CONSTRUCTION SUMMARY

Kingsmen (Thames) Inc. / Havelock Corners (Kingsmen)

Lot/Unit: 30 Phase/Building: 4B Model/Floor Plan: Lancaster(5001)Elev C 4 BED-3+1 BATH

SKETCH #2

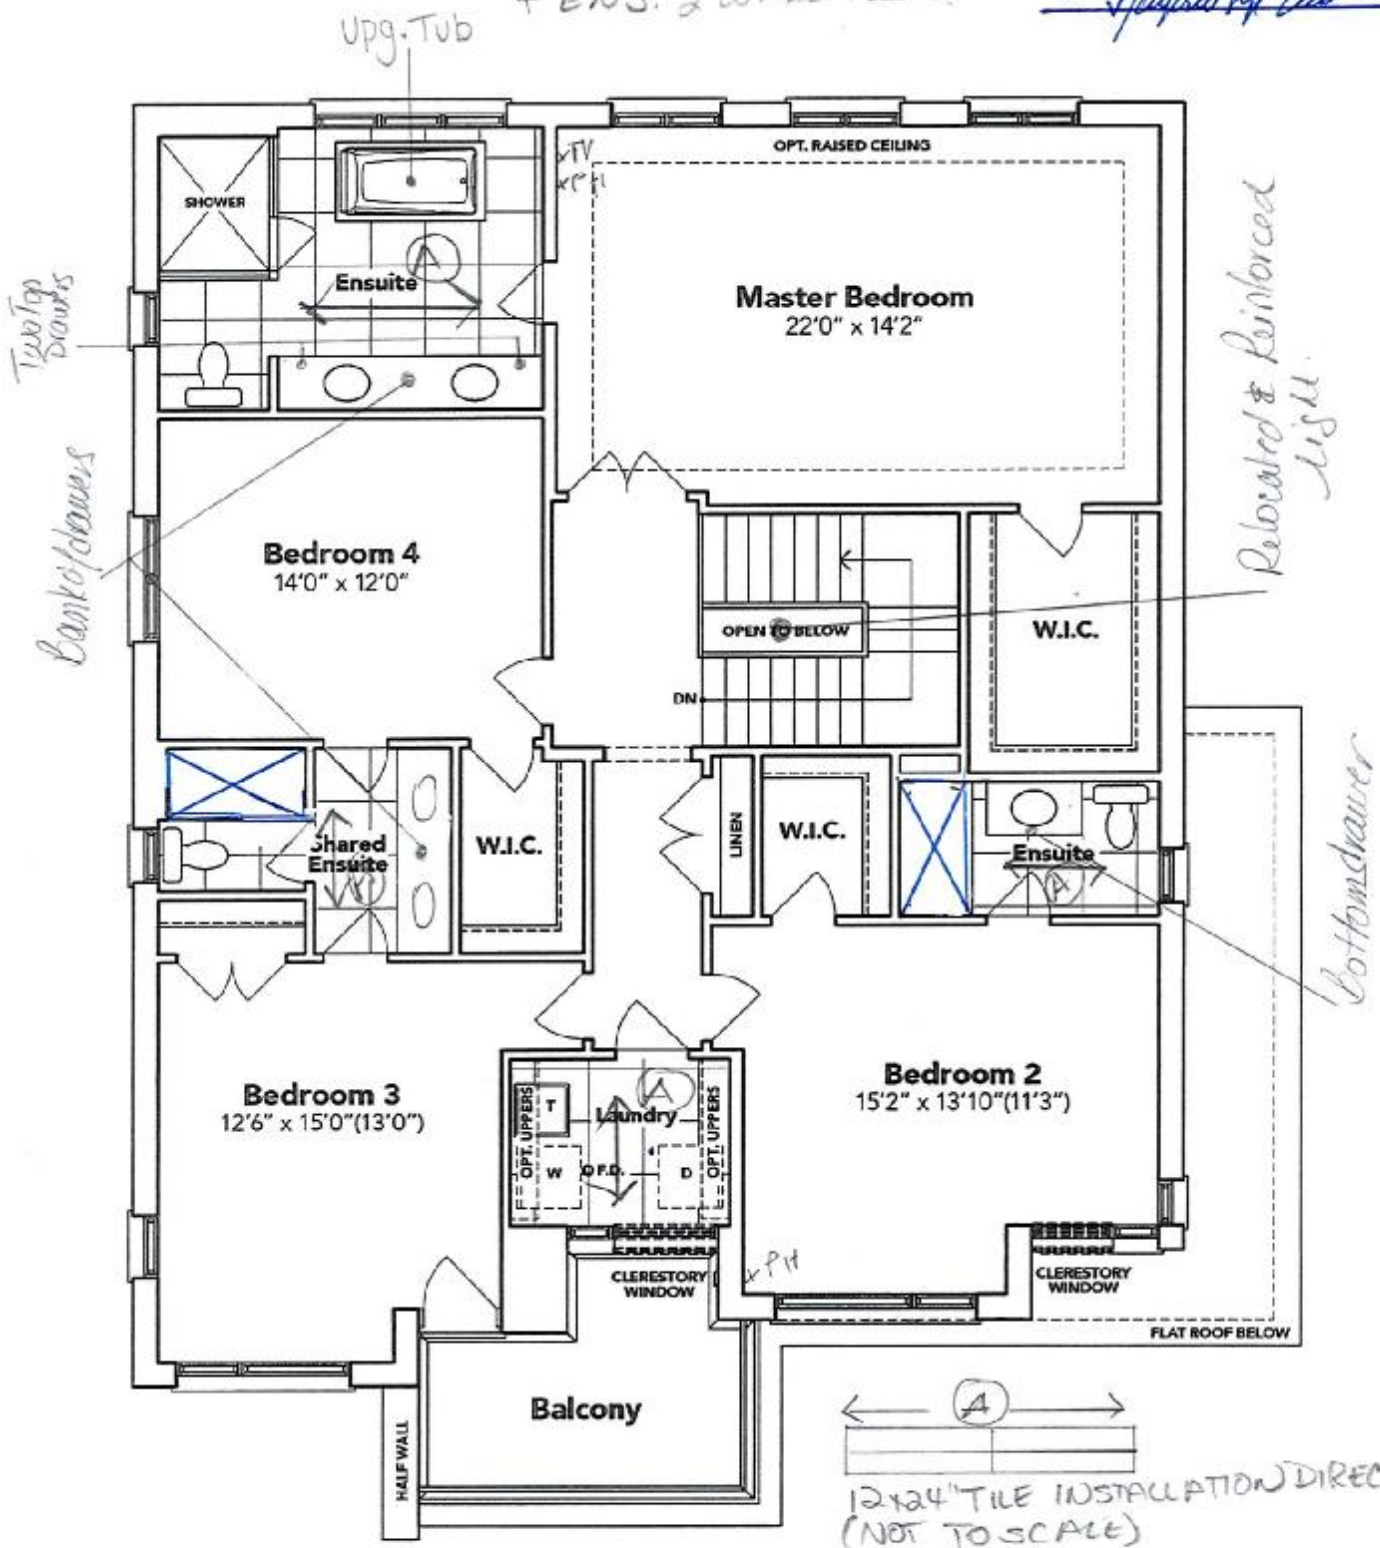
| Inv.5066 Line 66020 21Jul21 / 26Aug21 | 2 - To supply & install a VANITY - LOWER DRAWER PRICE PER DRAWER - CLASSIC SERIES in the ensuite #2 bathroom...see sketch # 2 Note: | |
| Inv.5066 Line 66021 21Jul21 / 26Aug21 | 1 - To supply & install a VANITY BANK OF DRAWERS - CLASSIC SERIES in the shared bathroom... see sketch # 2 Note: | |
| Inv.5066 Line 66022 21Jul21 / 26Aug21 | 1 - To supply & install a VANITY BANK OF DRAWERS - CLASSIC SERIES in the master ensuite bathroom... see sketch # 2 Note: | |
| Inv.5066 Line 66023 21Jul21 / 26Aug21 | 2 - To supply & install TWO VANITY TOP DRAWER - CLASSIC SERIES in the master ensuite... see sketch # 2 Note: | |

| Inv.5066 | 1 - Relocate the std. ceiling light from the main staircase landing to the O.T.B. area on the second floor....see sketch # 2 | |
| Inv.5066 | 1 - To SUPPLY AND INSTALL REINFORCING FOR A CEILING light at the O.T.B. area on the second floor at staircase...see sketche # 2 | |

| Inv.5066 | 2 - To change the bath tub from to a stand up shower (including frameless glass and a potlight) for the shared bathroom and Ensuite # 2.. see sketch # 2 | |

| Inv. 5066 | 1 - To supply & install the UPGRADE 3 - FLOOR TILE - STACKED - ENSUITE FLOOR TILE in lieu of the standard floor tiles. ..see sketch # 2 for installation direction. | |
| Inv. 5066 | 1 - To supply & install the UPGRADE 3 - FLOOR TILE - STACKED - ENSUITE # 2 FLOOR TILE in lieu of the standard floor tiles. ..see sketch # 2 for installation direction. | |
| Inv. 5066 | 1 - To supply & install the UPGRADE 3 - FLOOR TILE - STACKED - SHARED BATHROOM FLOOR TILE in lieu of the standard floor tiles...see sketch # 2 for installation direction. | |

| Inv. 5066 | 3 - To install the standard wall tiles on the 10" side horizontally in a 70/30 + - off set brick pattern for the master ensuite, ensuite # 2 and the shared bathroom where applicable.... see sketch # 2 | |

70/30⁺ OFFSET
BRICK PATTERN
FOR MASTER ENS. SHARED
+ ENS. 2 WALL TILES

Sketch #4

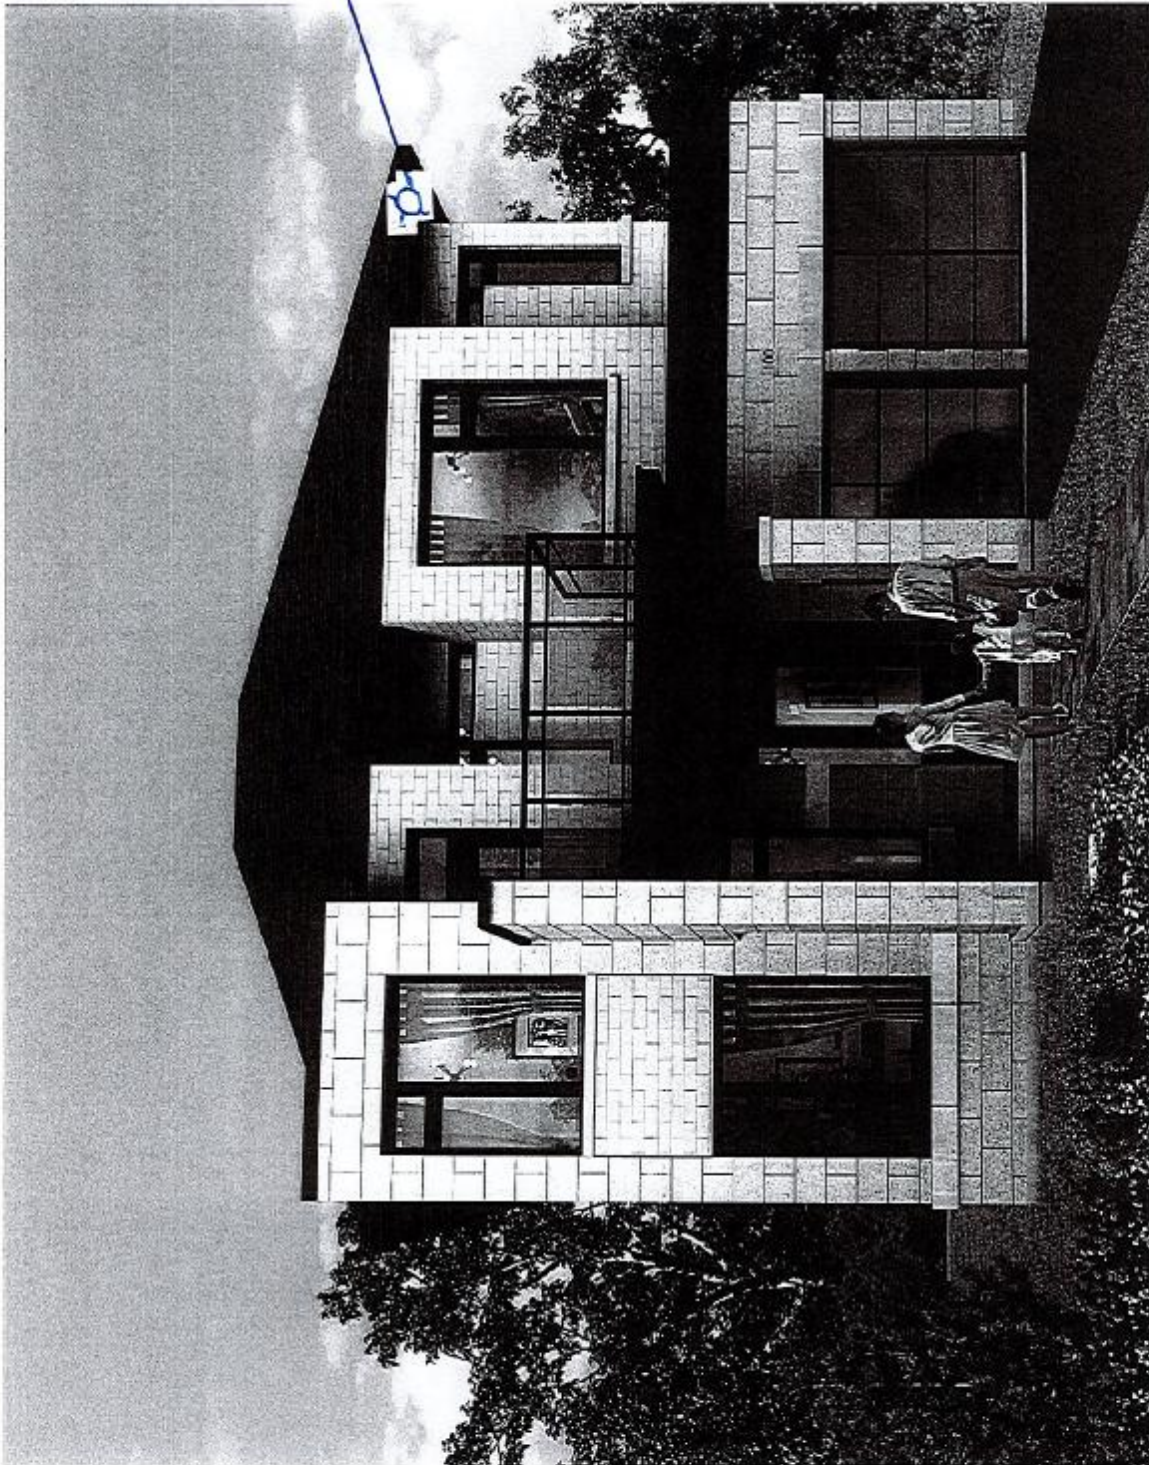
| Inv.5066 | 1 - To supply & install ONE LED exterior pot light on a sep. switch... see sketch # 4 | |

ONE EXTERIOR
POTLIGHT

THAMES 4B: LOT 30
RE:UPG BATHROOM SINKS (PWD,
MASTER ENSUITE, BEDROOM #2 &
SHARED BATHROOM)

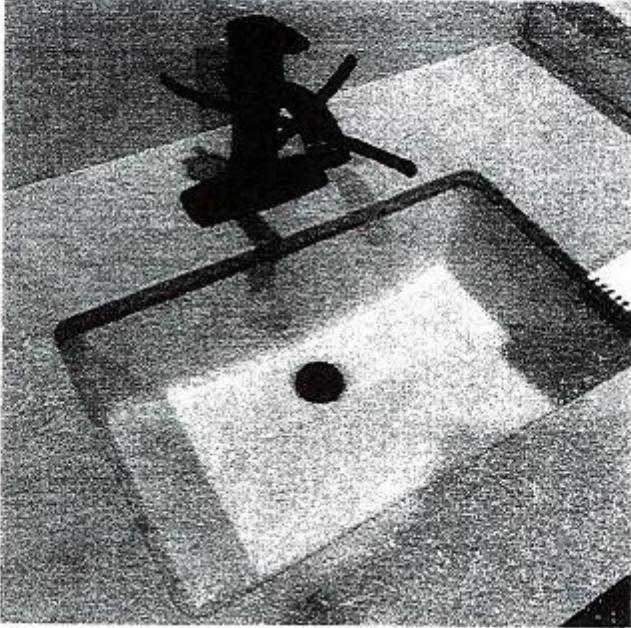
| Inv. 5066 | 6 - To supply & install the CONTRAC CATENA model 4210CIY under mount sinks to the powder room, master ensuite, ensuite #2 and shared bathroom in lieu of the std. vanity sinks...see spec's | |

THAMES 4B: LOT 30
RE:UPG MASTER ENSUITE TUB

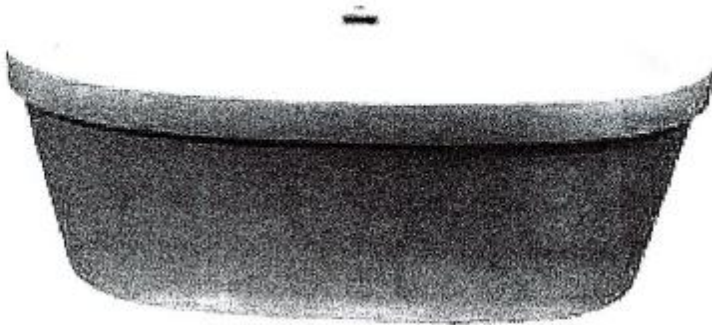
| Inv.5066 | 1 - To supply and install the Mirolin Brooke free standing tub in the Master Ensuite, in lieu of the standard free standing tub... see spec's | |
